February 22, 1979
L-79-45

Re: St. Lucie Unit 1
Docket No. 50-335
Proposed Amendment to
Facility Operating License DPR-67

Re: St. Lucie Unit 1
Docket No. 50-335
Cycle 3 Operation

RELOAD SAFETY EVALUATION

FIGURE 2.2-2
Local Power Density-High Trip Setpoint
Part 2 (QR₂ versus Y_I)

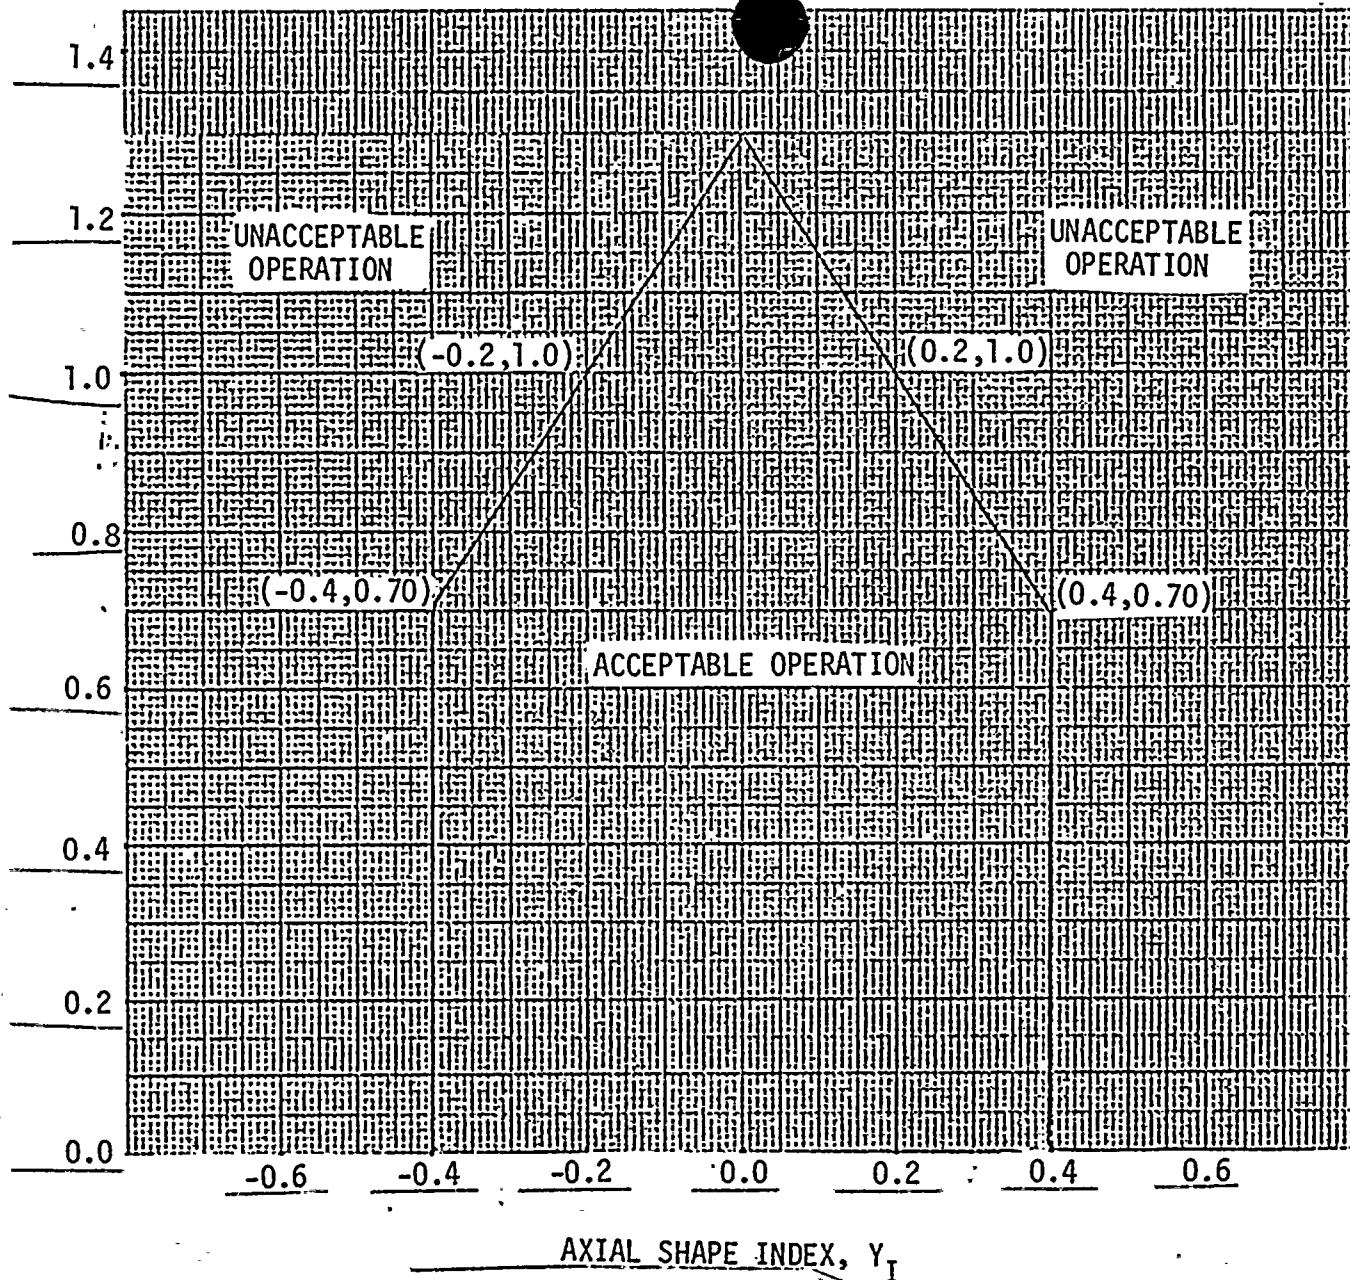
Figure 2.2-2 is revised based on the Cycle 3 analysis.

Figure 3.2-1 Allowable Peak Linear Heat Rate vs Burnup

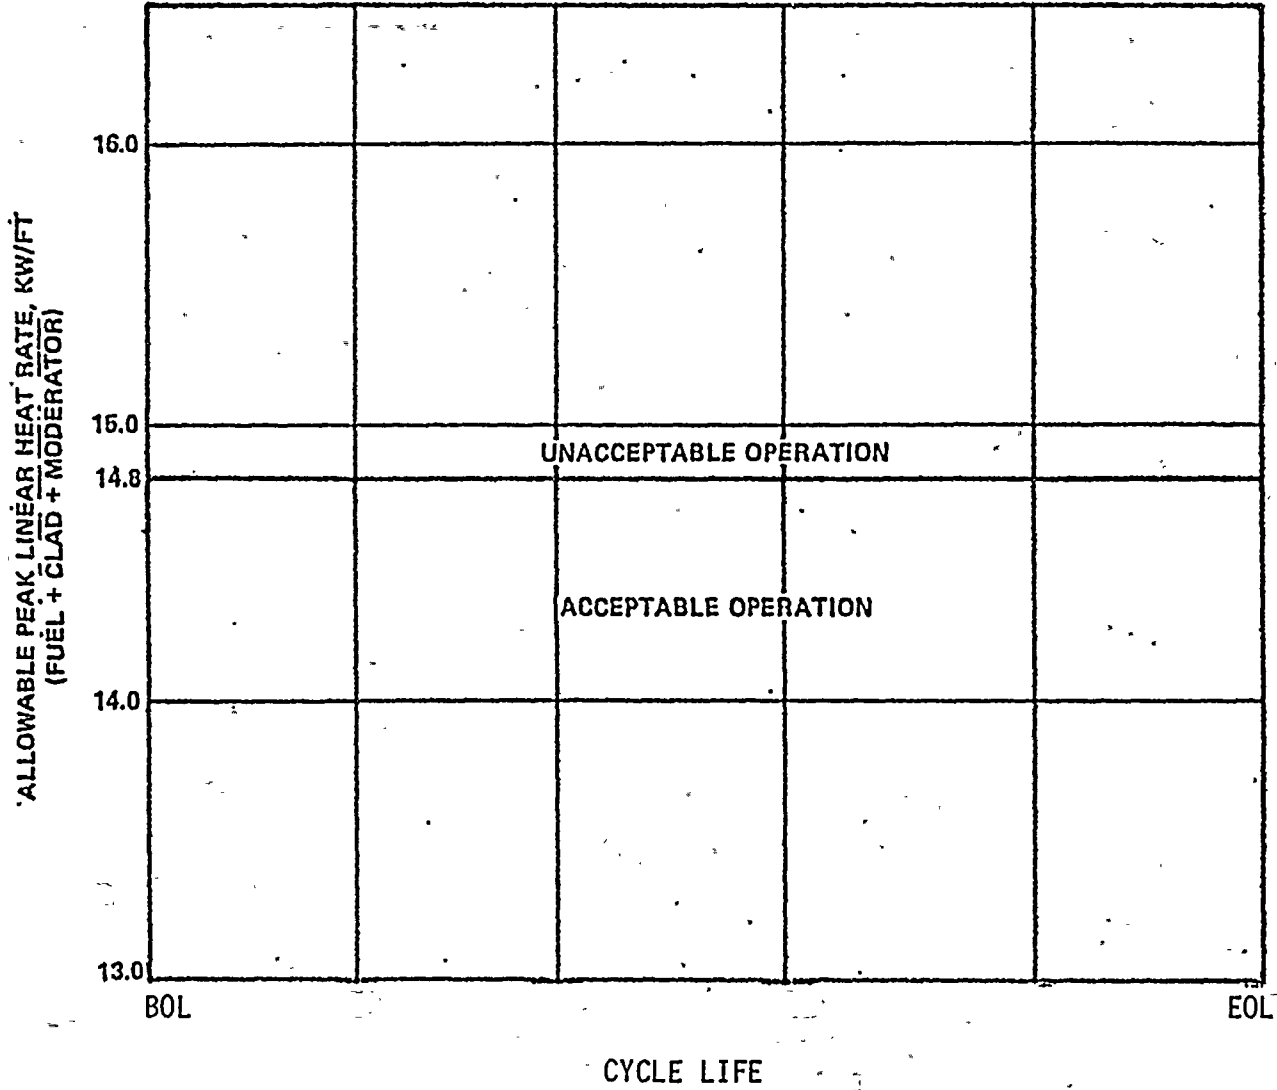
Figure 3.2-1 is revised to extend its applicability beyond Cycle 2.

FIGURE 3.2-2
 AXIAL SHAPE INDEX vs. Fraction of Maximum
 Allowable Power Level per Specification 4.2.1.3

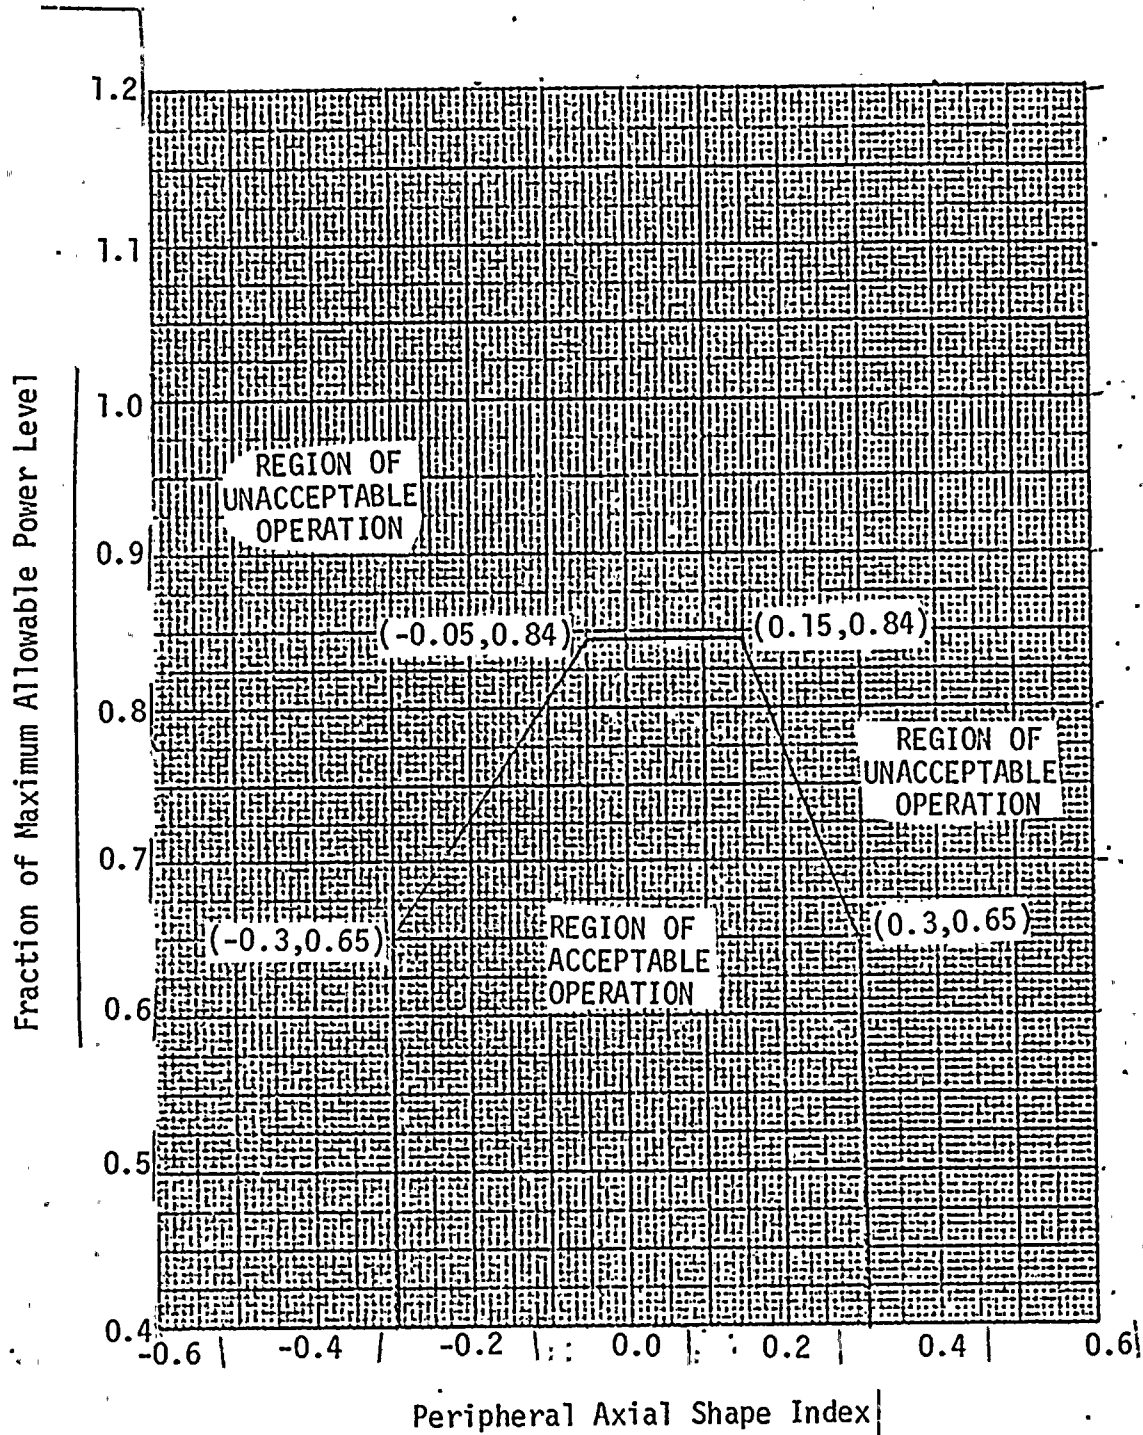
Figure 3.2-2 is revised based on the Cycle 3 analysis.

Figure 4.2-1 Augmentation Factors vs. Distance from Bottom of Core

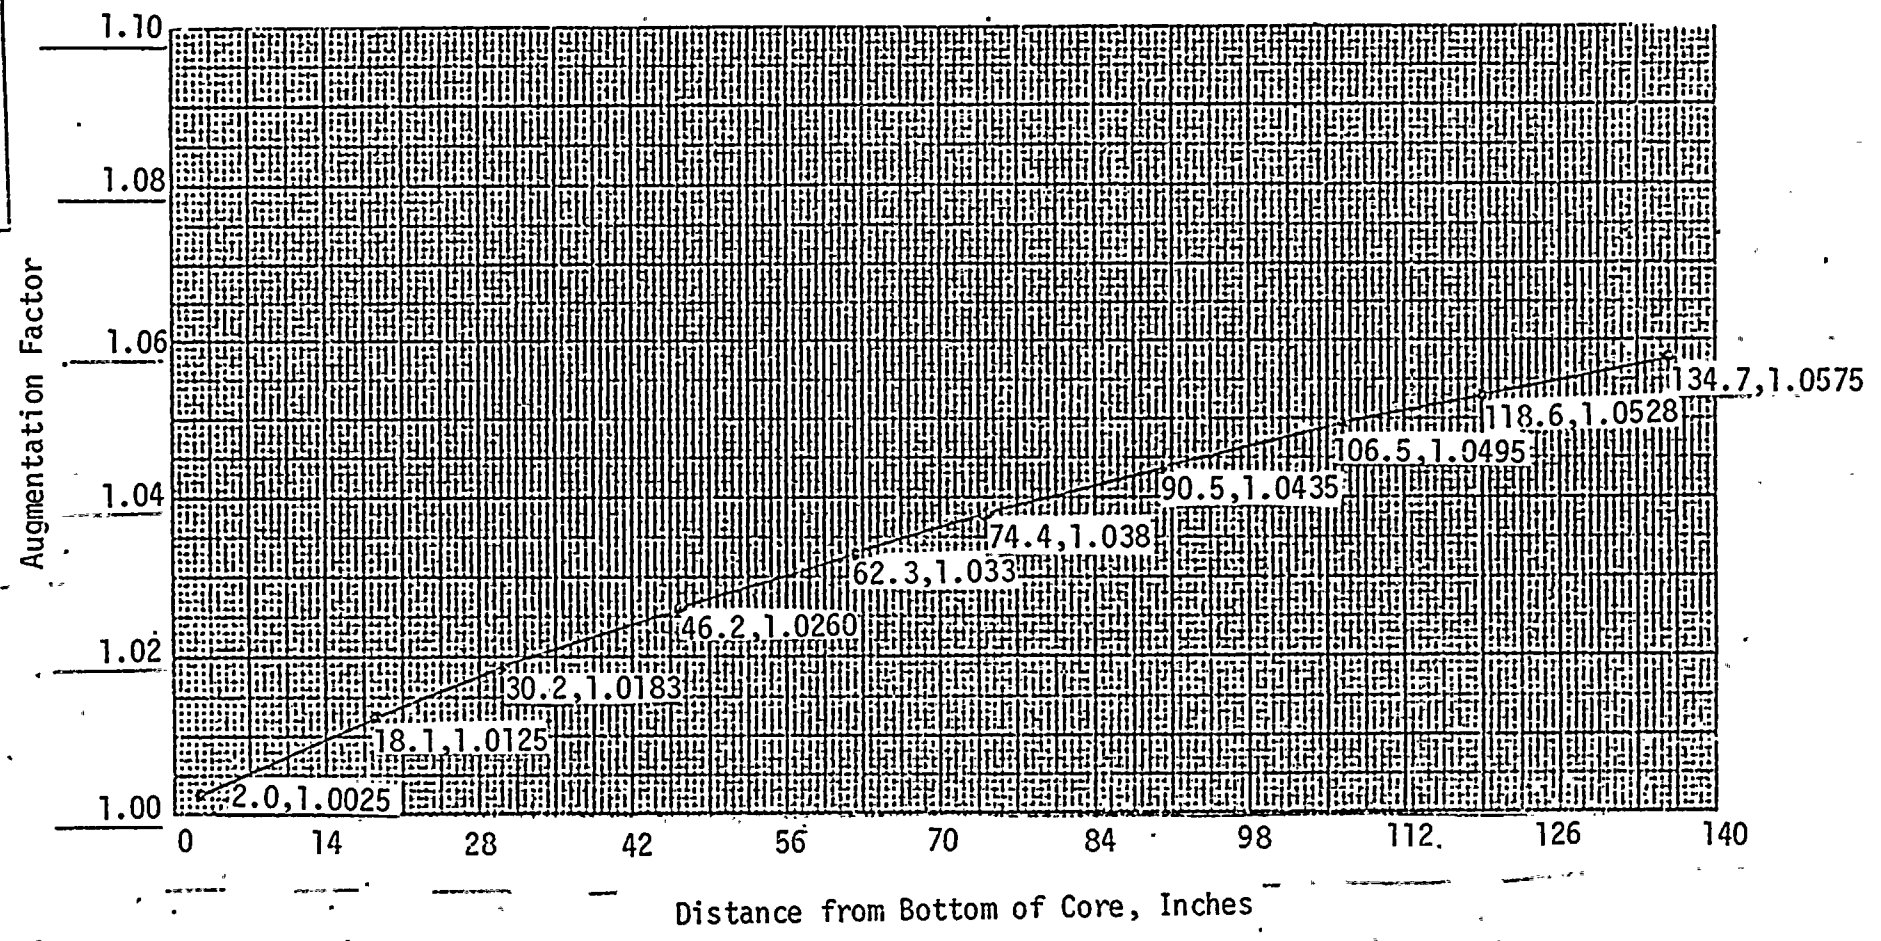
Figure 4.2-1 is revised based on the Cycle 3 analysis.

FIGURE 3.2-3a

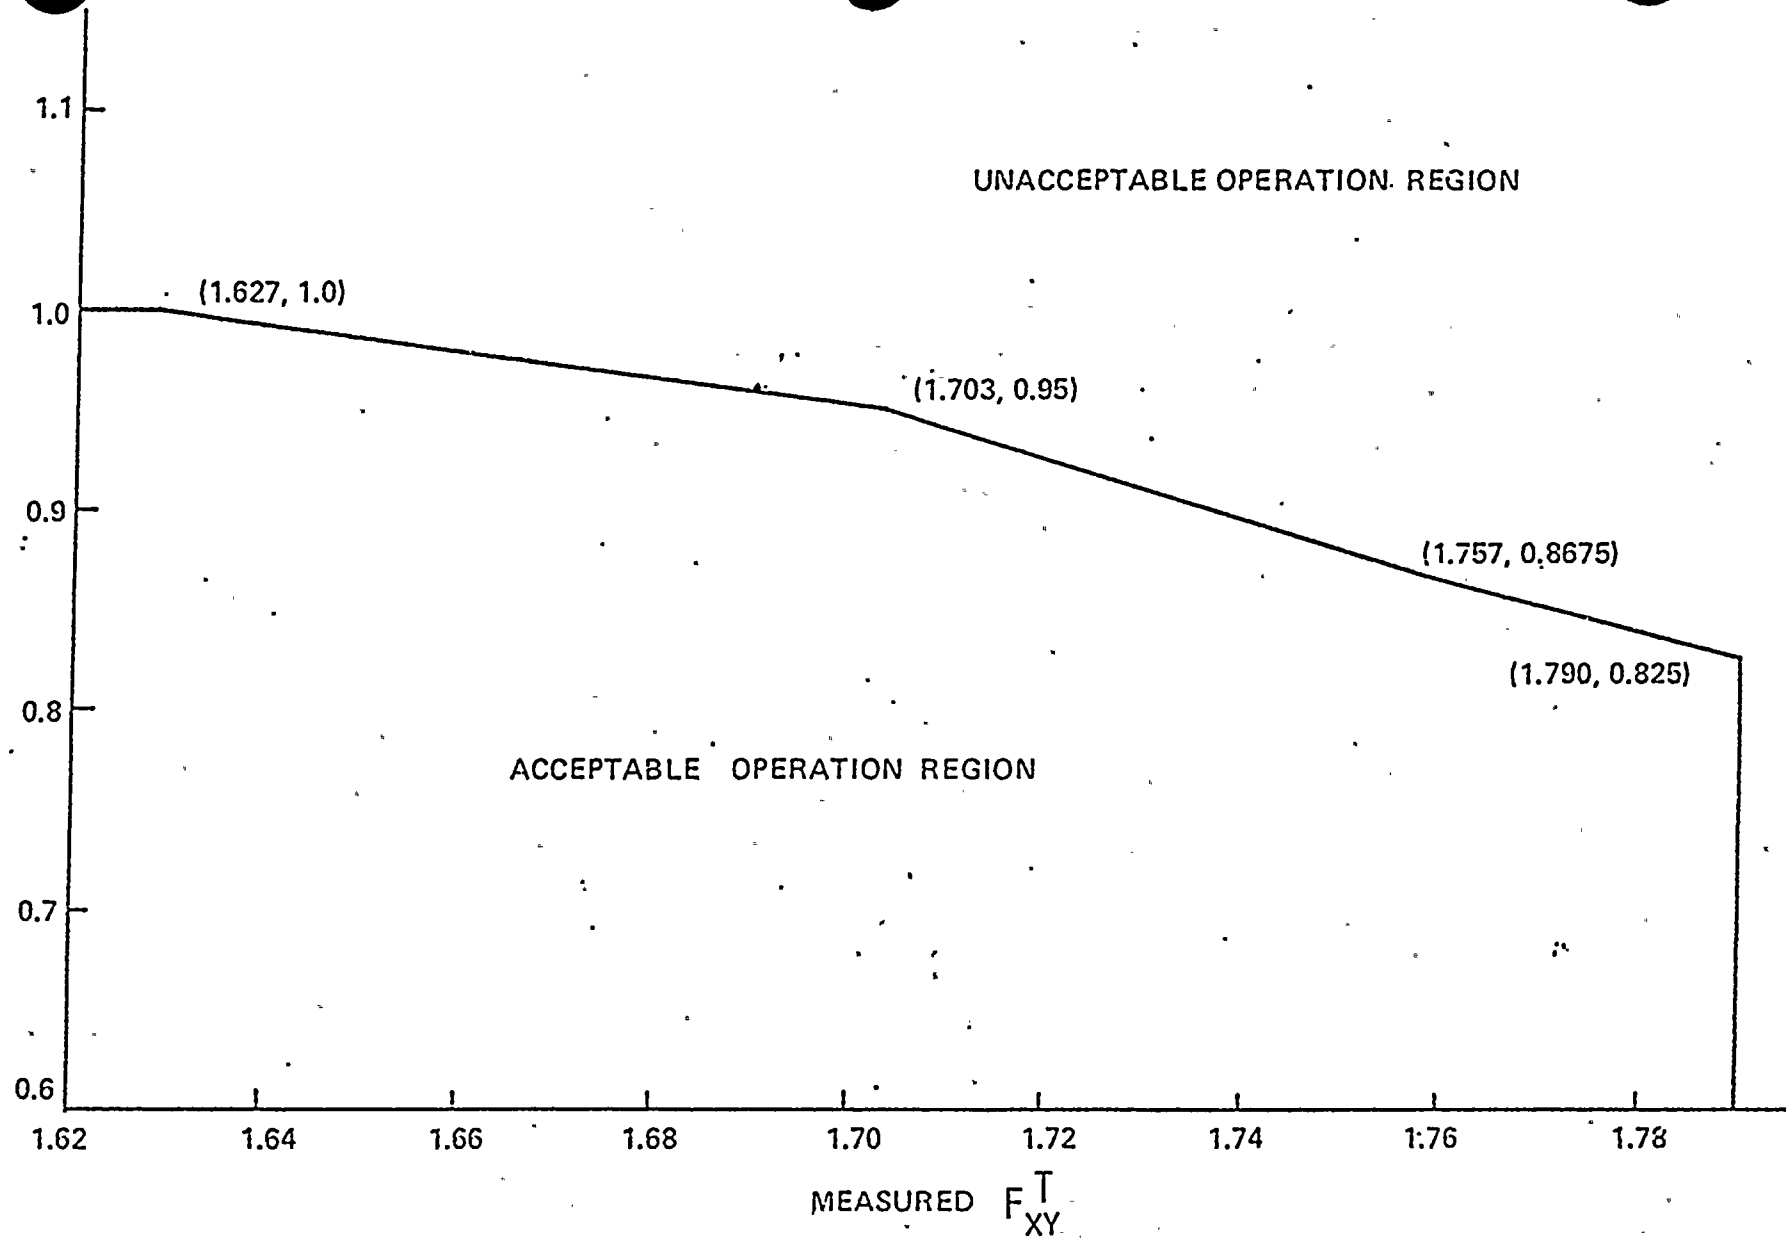
A separate Figure 3.2-3a is provided to show the allowable combinations of thermal power and total planar radial peaking factor, based on the Cycle 3 analysis.

FIGURE 3.2-3b

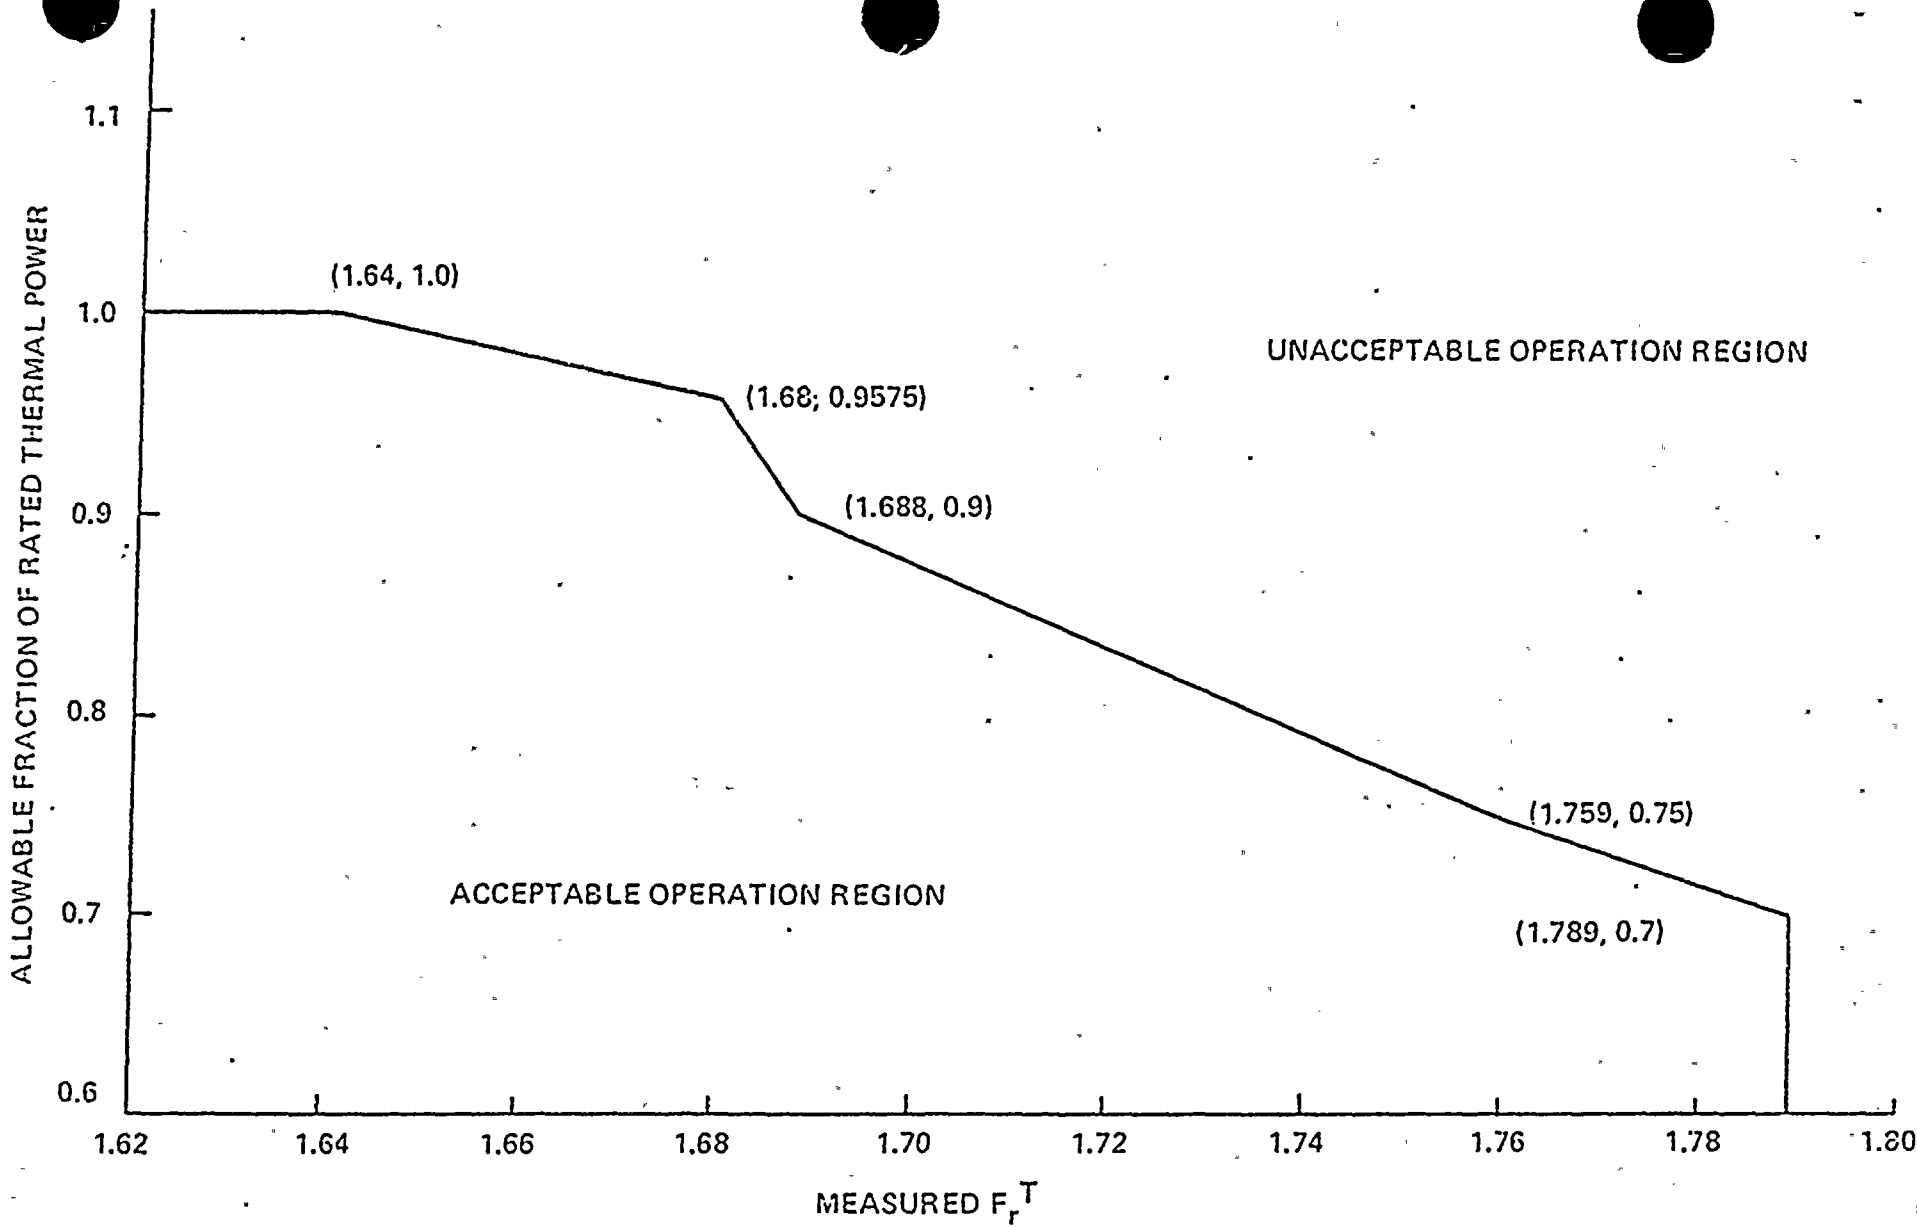
A separate Figure 3.2-3b is provided to show the allowable combinations of thermal power and total integrated radial peaking factor, based on the Cycle 3 analysis.
